Central Valley Regional Water Quality Control Board

NOTICE OF VIOLATION AND REPORT OF RECENT INSPECTION, WILD WINGS WATER RECYCLING FACILITY, YOLO COUNTY

INSPECTION REPORT

Figure 1. Package plant.

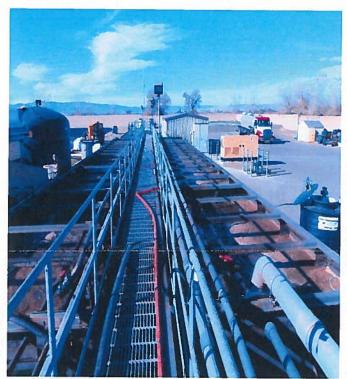
Wastewater was being treated in the aeration basins and secondary clarifiers (Figure 1). The flocculent tank and tertiary filters were bypassed. Sand from the tertiary filters was observed on the ground adjacent to the filters (Figure 2). Secondary treated wastewater was discharging into the recycled water pond. Solids were observed on the liner of the recycled water pond below the effluent discharge pipe. Freeboard in the recycled water pond appeared to be about 15 feet. Engineers assessing the treatment plant explained that a blockage downstream of the clarifiers caused the water levels in the treatment system to rise and allowed excess solids to pass over the clarifier to the tertiary filter system and ultimately into the recycled storage pond.

Figure 4. Storm water basin with solids from the WWTF.

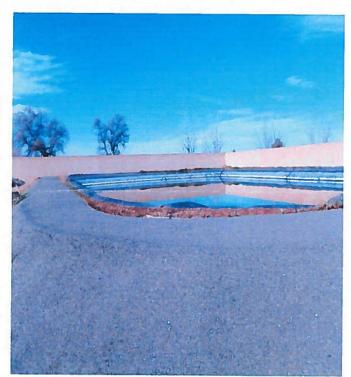
The facility's storm water basin contained solids associated with overflows from the treatment facility (Figure 4).
